MEETING AGENDA

The City of Beaufort

DESIGN REVIEW BOARD

A. Battery Creek Apartments, PIN R120 028 00A 0409, 0410, 0411, 0412, 0413 0000, 25 Old Jericho Road.

A1.13

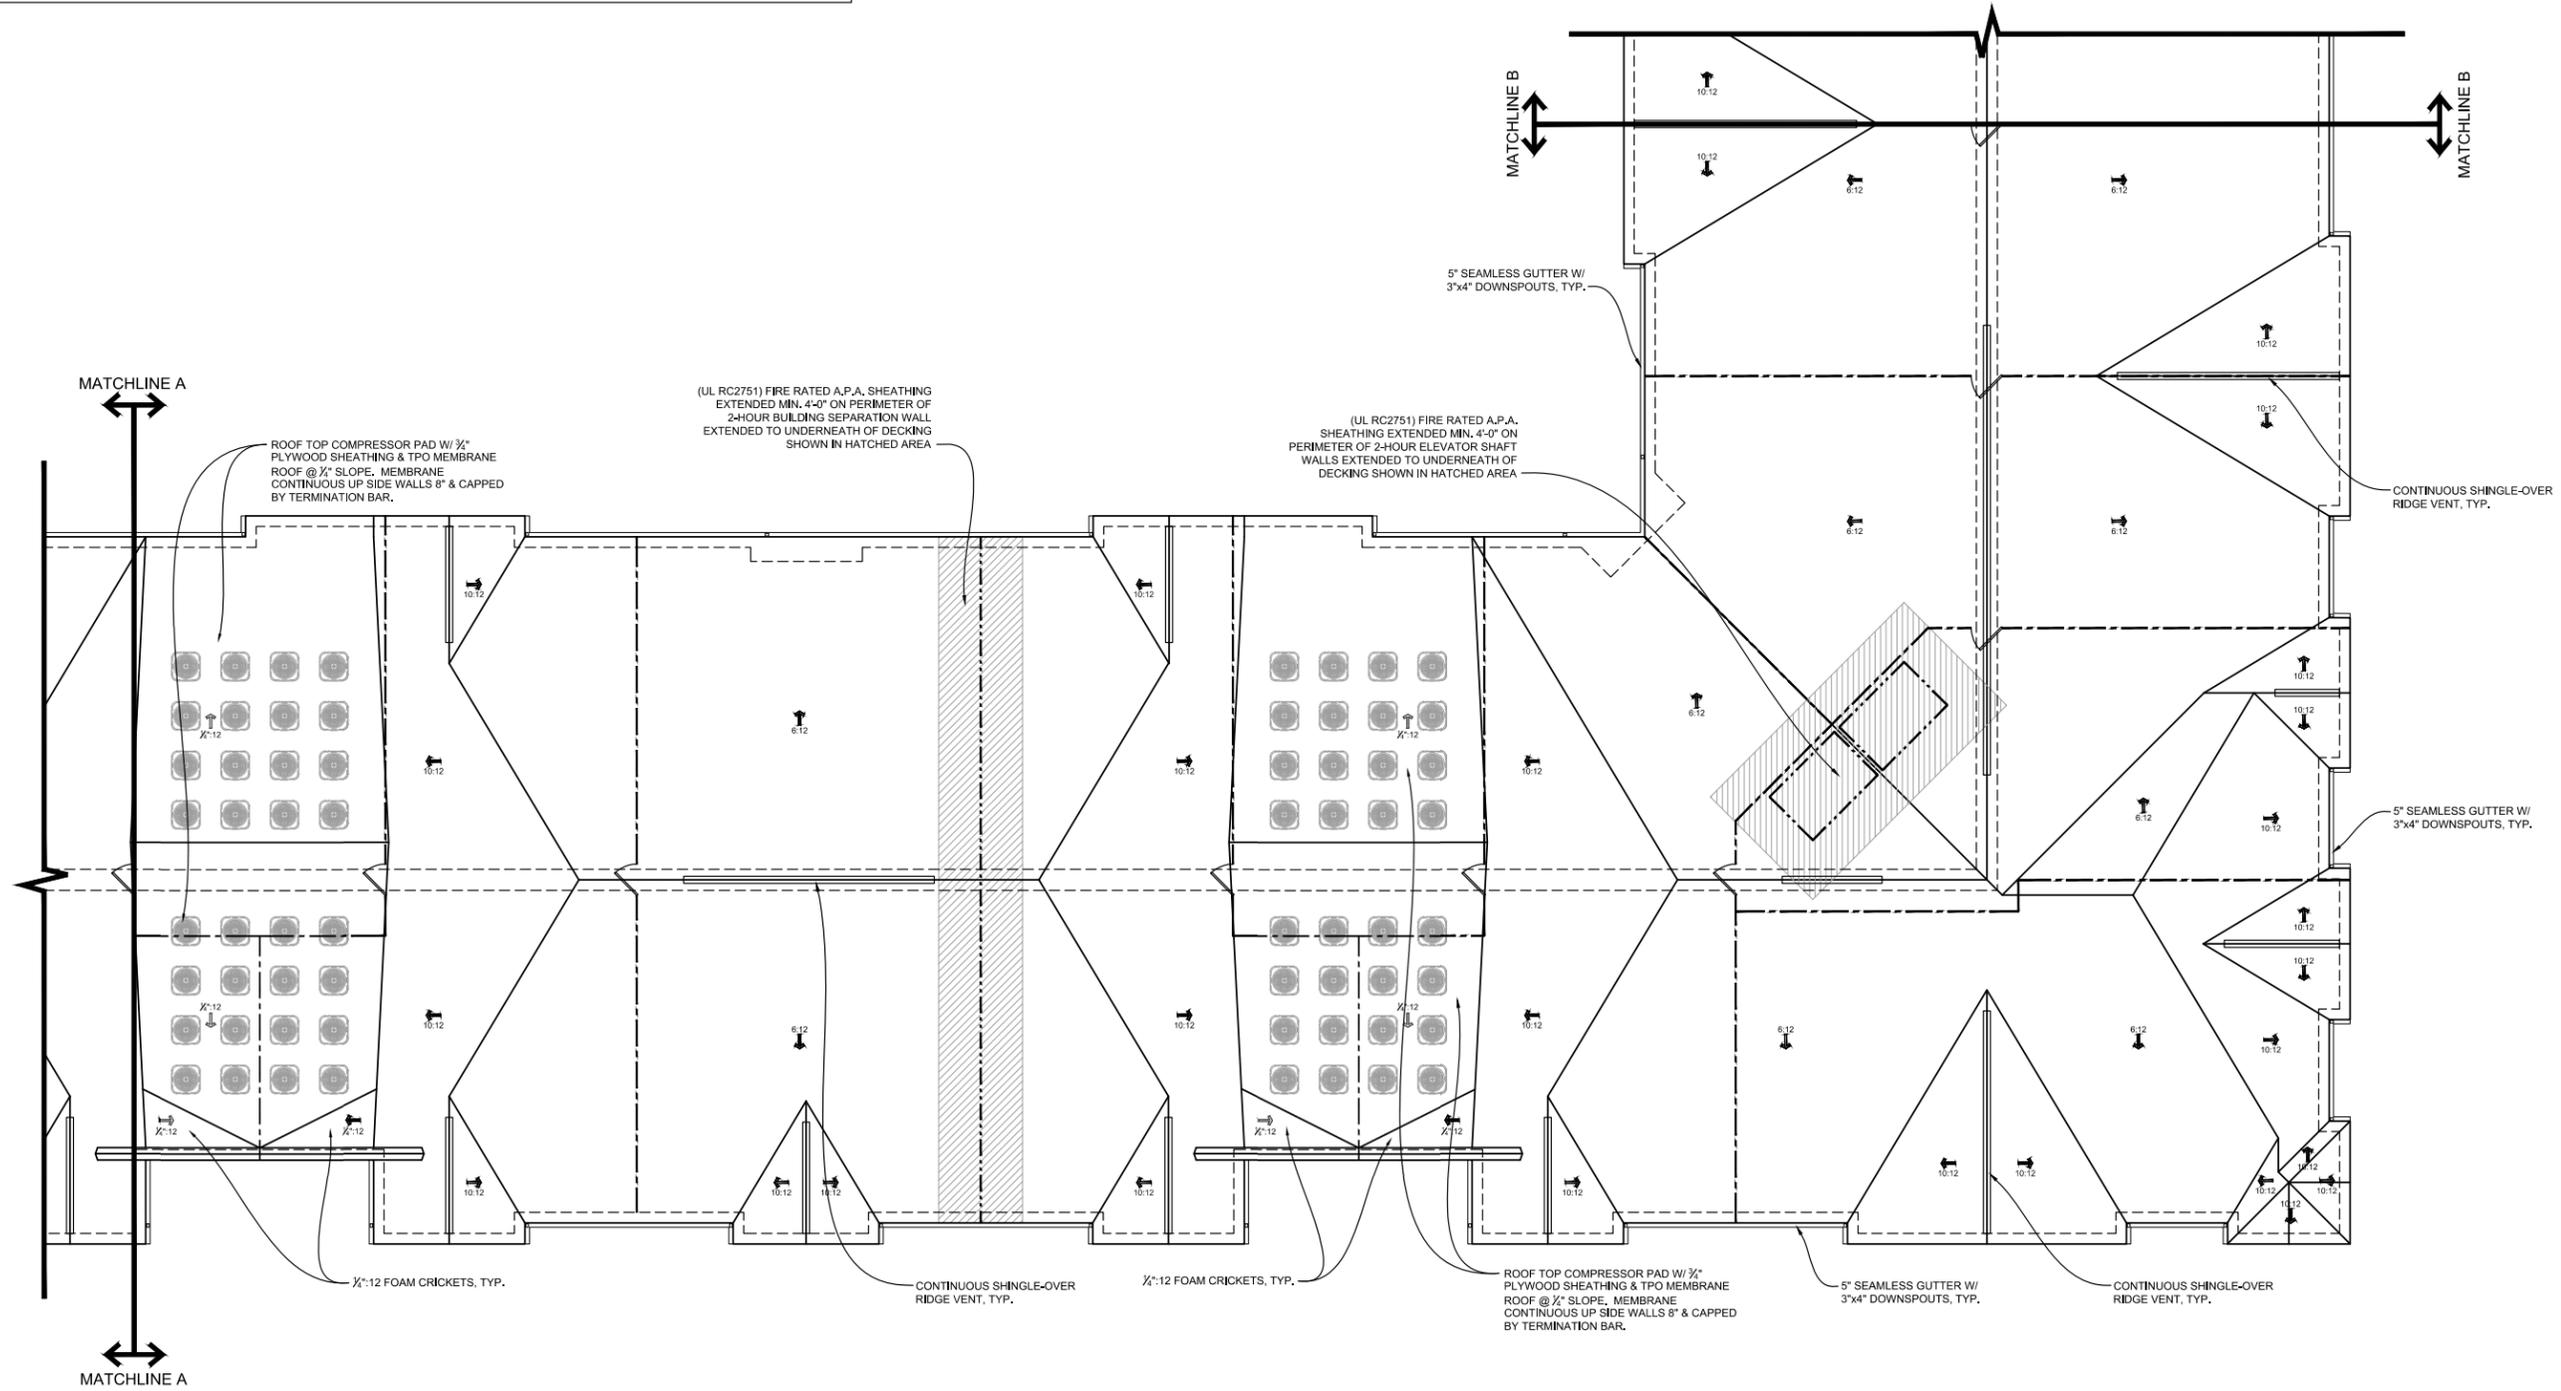
front gable on either side as shown on the east façade. On the east façade, the flat roof is appropriately recessed between two gable roofs (see sheet A1.13).

4 EXTERIOR WALL SECTION DETAIL @ BRICK SOLDIER COURSE TO TRIM BAND (UL U356)

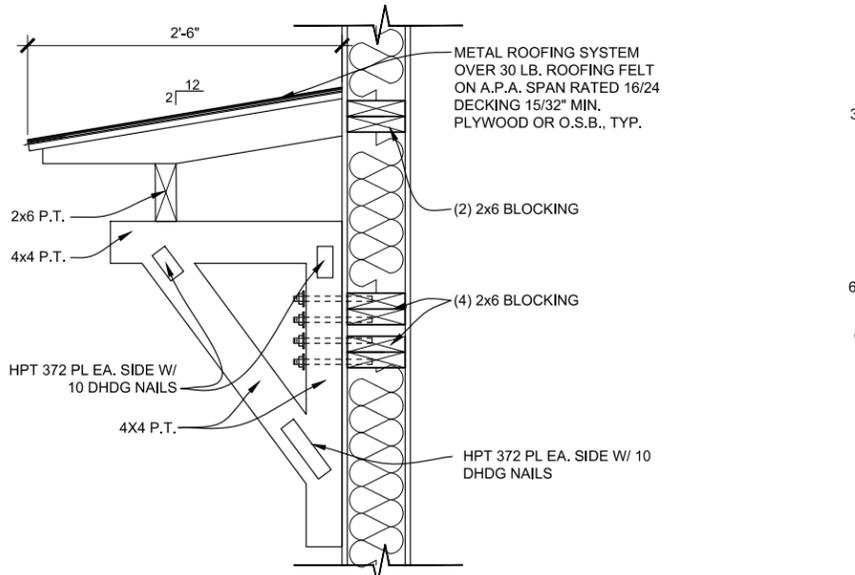
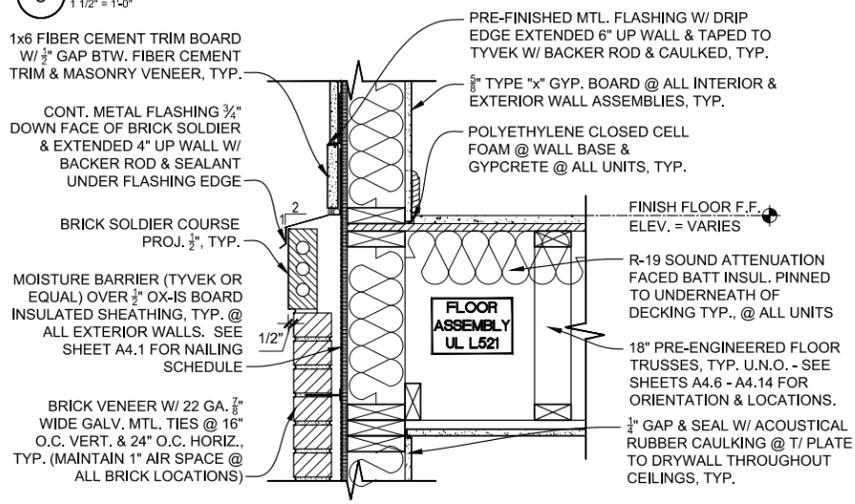
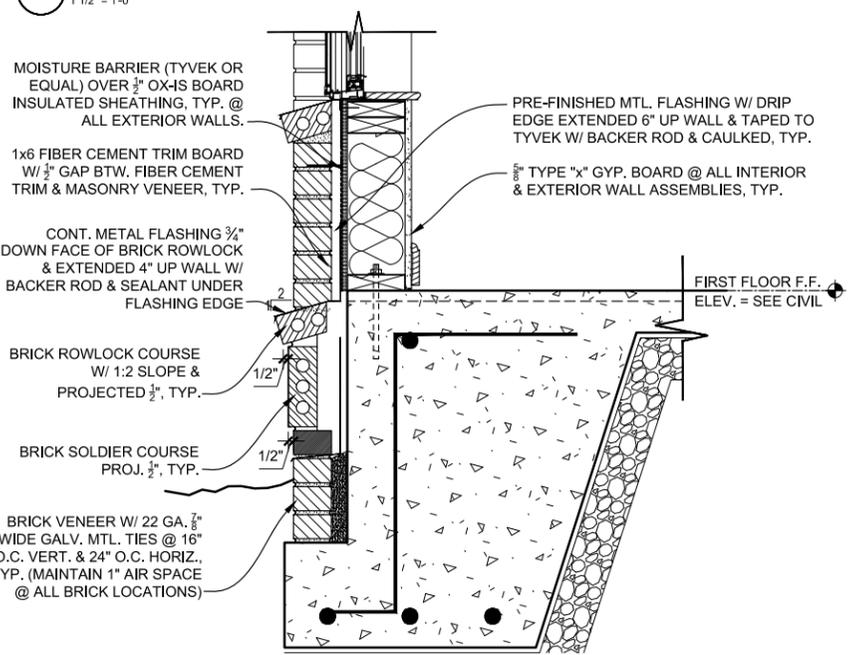
- a. See unit plan sheets A2.1 & A2.2.
4. Staff supports the use of the awnings on the tower structures; applicant to submit a section drawing through the awnings.

- a. See detail 4, sheet A1.17 for awning section detail.
5. Applicant has provided an appropriate roof detail showing the parapet roof. Applicant has also provided a roof plan showing the HVAC units on the roof, staff supports this.

5 WATERPROOFING DETAIL @ SIDING WINDOW SILL
1 1/2" = 1'-0"

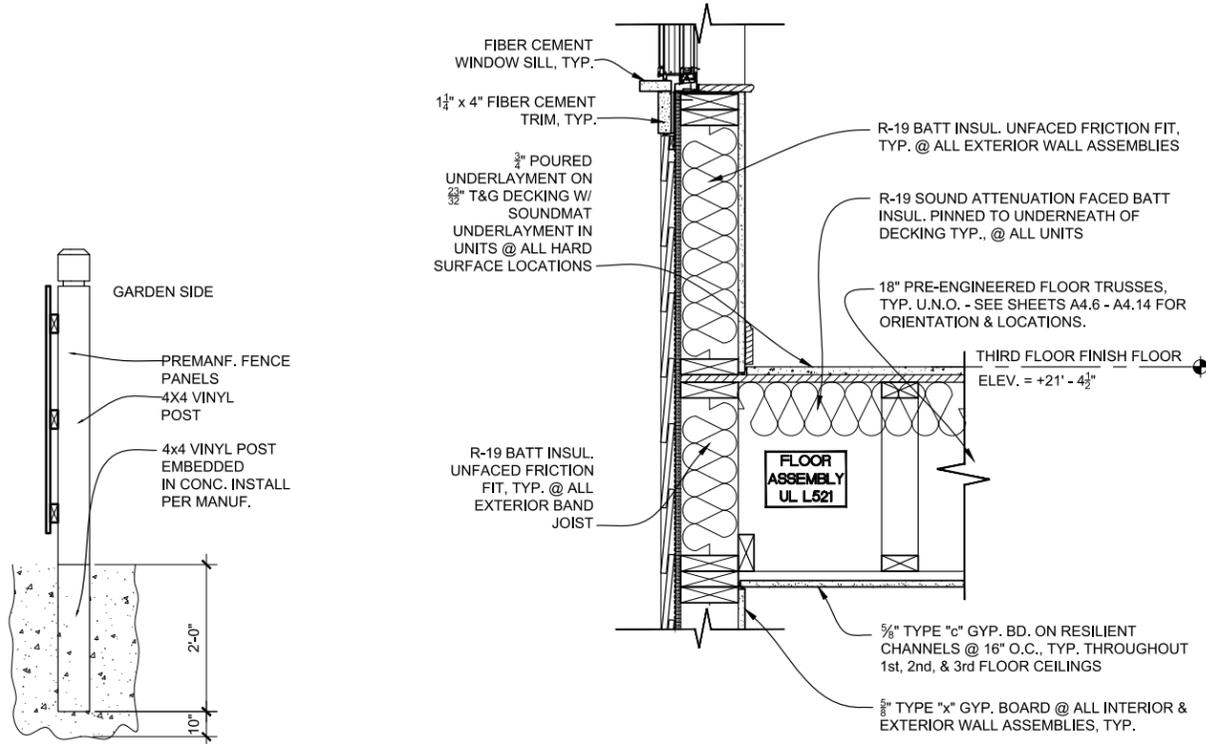
- a. See sheets A1.2, A1.16, A3.2, A3.7 & A3.8.
15. Staff believes the applicant does not adhere to Section 4.6.3.C.2.a regarding window treatments. The current design illustrates the fiber cement head and sill casings flush with the outside face of the window as well as the outside face of the lap siding. Staff recommends the applicant switch to a 1 ¼" fiber cement trim for all windows, doors, corner boards, skirtboards, etc. to provide proper reveals and shadow lines to all windows, doors, and siding.

- a. See detail 5, sheet A1.18. Changed fiber cement trim to 1 ¼".
16. Staff believes the main roof at the two-bay tower connection on the west facade (labeled partial front elevation) on sheet A3.1 creates an odd connection with the low-sloped roofs. Applicant to redesign these roof areas to more properly balance with the geometry of the architecture. Staff recommends the applicant mirror the pattern of the bays and tower elements on the west façade so that it matches the east façade facing Salem Road.

4 BRICK SCREENING WALL WITH PROJECT SIGNAGE
3/4" = 1'-0"

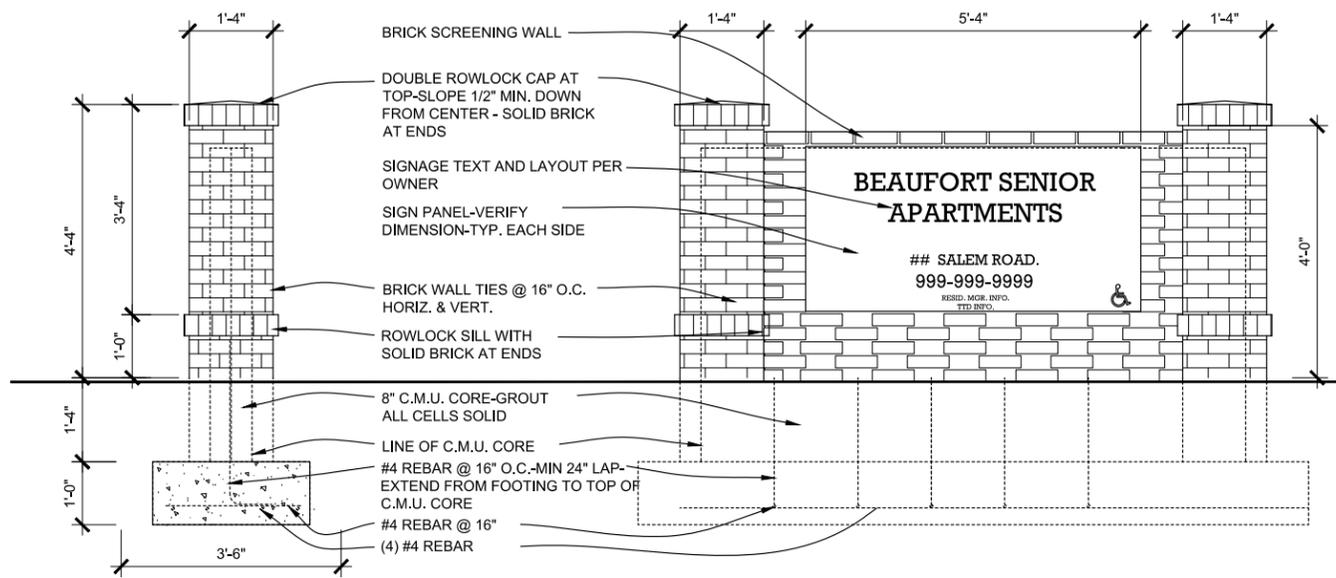
- a. See sheet LP.1.
4. Applicant to demonstrate compliance with Section 5.8 Lighting.
 - a. Shall be provided in future submission.
5. Applicant has demonstrated that the parking area will be screened with a brick wall; staff supports this element. Applicant to provide details for this brick wall at future submission.

- a. See sheet A1.18
6. Staff recommends the applicant include additional screening along the southern and northern edges of the property to screen the parking from Salem Road. Applicant to refer to Section 5.7.8 for screening shrub or wall requirements.

A3.8

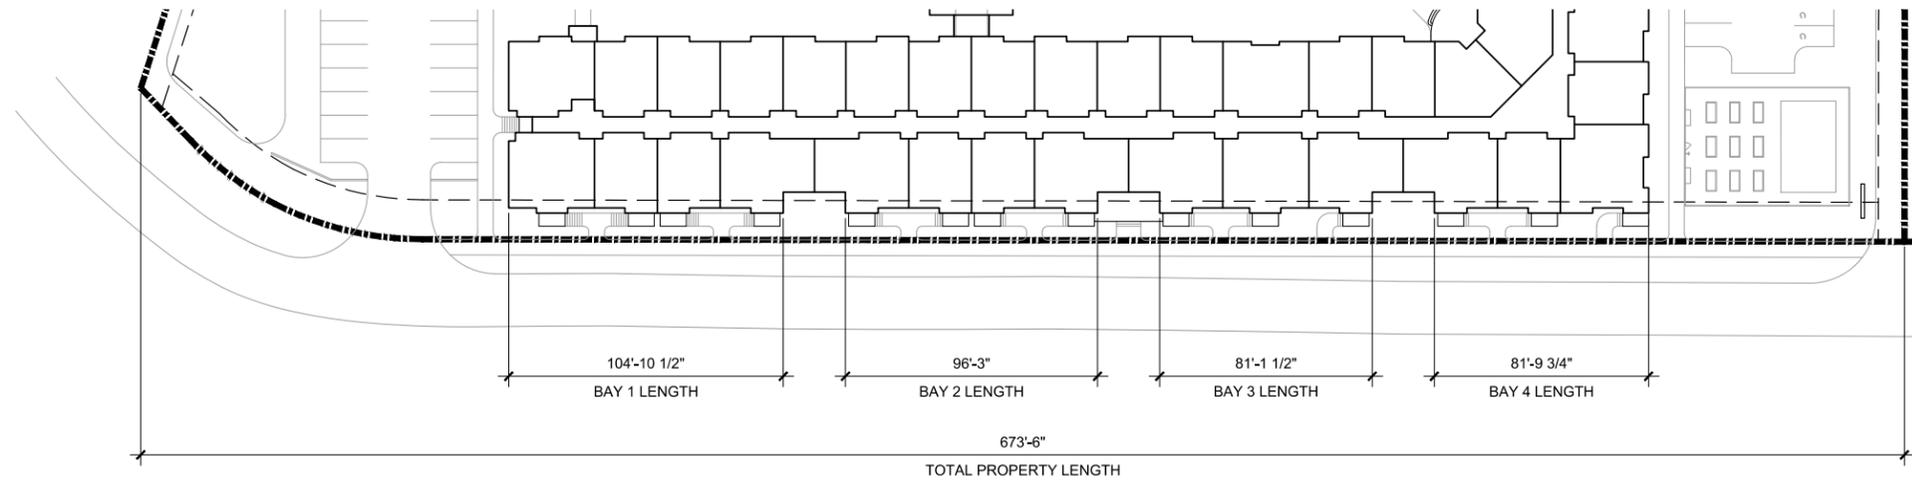
- a. Changed the cross gable. See sheets A3.1 – A3.9.
6. Staff recommends the applicant provide one 3D view of the west elevation to show how the pitched roof to flat roofs are resolved in 3D rather than just having 2D elevations of this condition.

- a. See sheets A3.8 .
7. Extend sidewalk to the south of the ingress/egress drive to property line and provide pedestrian crossing marking at ingress/egress drive.
